# NABCO ENTRANCES TECHNICAL BULLETIN

Date: August 23, 2012

## **Changes to the Magnum Control**

Bulletin Number: 57

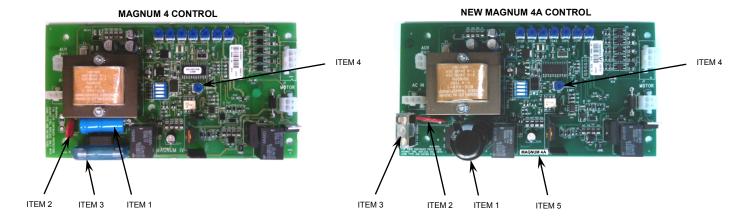
- 1. Refer to Item 1. The capacitor used to filter power to the motor has been replaced with one that is significantly larger. This will reduce capacitor failures as well as reduce motor "hum".

- Refer to Item 2. The value of the MOV (Metal Oxide Varistor) has been increased to be more resistant to failure caused by power surges.
- The signal input circuits have been modified to be more immune to electrical noise that can cause false triggering.

- 4. Refer to Item 3. The fuse and fuse holder have been changed from a 1-1/4" x 1/4" to a 5 x 20mm type more commonly found worldwide. The holder also includes a snap-on cover. The fuse is still rated for 5 amps.

- 5. Refer to Item 4. The current limit adjustment range has been increased to accommodate a wider range of door opening speeds.
- 6. The new control is identified by the name "Magnum 4A" located at the edge of the board as shown in Item 5 below.
